DESIGN & CONSTRUCTION MANUAL DESIGN CRITERIA MODIFICATION REQUEST

PROJECT NAME: Petsites – Lee's Summit, MO

PERMIT NUMBER: PL2021039

STORMWATER MANAGEMENT PLAN

C-501

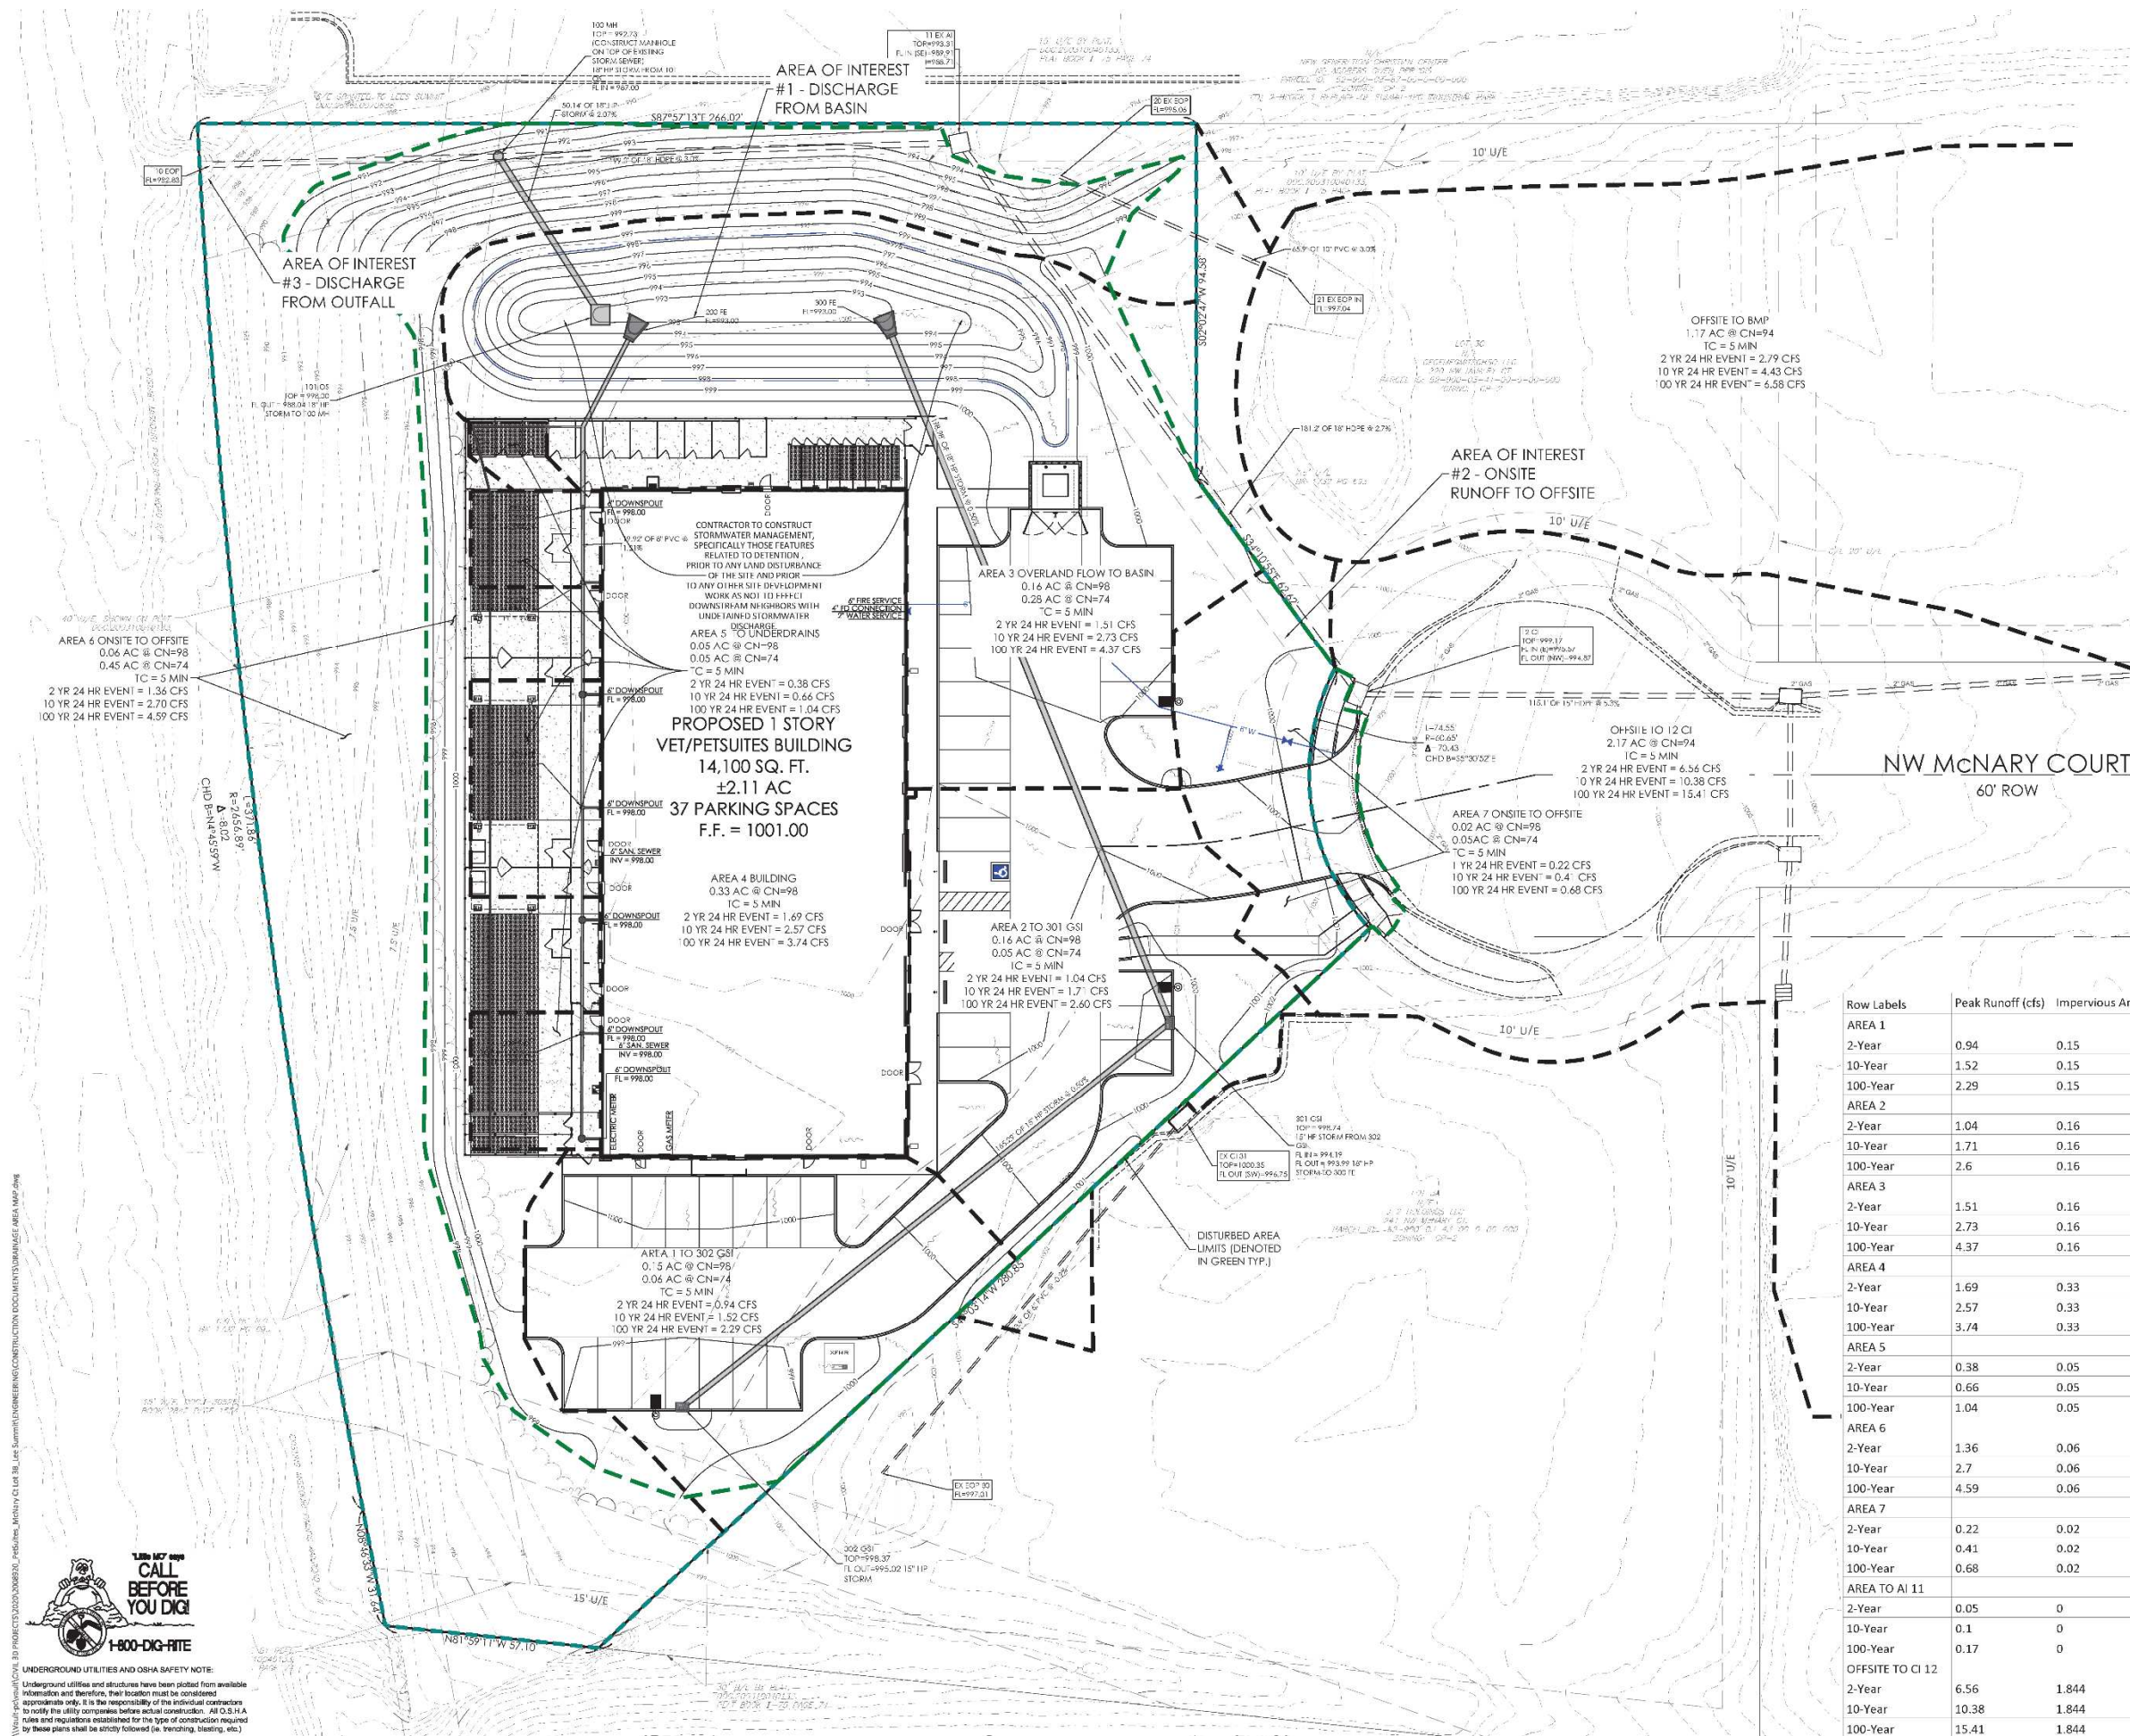
We are requesting this waiver for section 5601.5.A.4.a – default strategy: comprehensive Protection Attached with this submittal are the construction documents and stormwater report that contains the justification for removing the requirement for the peak runoff control for the 1%, 10% and 50% to accommodate leaving the existing trees to the west of the project. To meet the requirement, we would have to remove the existing trees to remain.

The listed waivers as shown below are being requested for the post developed condition to allow the increase from the allowable release rate due to the Bypass Areas associated with the existing vegetation to remain instead of routing those areas to the basin. This waiver would be for the 2 Year, 10 Year and 100 Year Events. The proposed project will increase the impervious surface however it will reduce the runoff for the overall disturbed area per APWA 5600. This project proposes that areas that will route through the detention will meet the allowable release rate. The bypass areas consist of existing woodlands that will remain in place therefore to meet the requirements we would have to remove the existing vegetation in place.

The water quality orifice size is 1" for this project. This will allow for the water quality orifice size to meet the City's requirements while being slightly lower for the volume due to the decreased area to the basin. We are reducing the overall runoff for this project. While we are requesting waivers, this is only due to limiting the disturbed area to keep the woodlands in place.

COMMENTS: The Development Engr. Group supports the requested waiver to the allowable release rates for the proposed site. (The disturbed areas of the project, that are able to be routed through the basin, do meet the allowable release rates.) We are in concurrence that removing the existing vegetated area to the west of the proposed building would be worse from a water quality standpoint than the benefit gained from trying to route this area through the detention basin. The applicant has demonstrated an overall decrease in runoff from existing to post development.
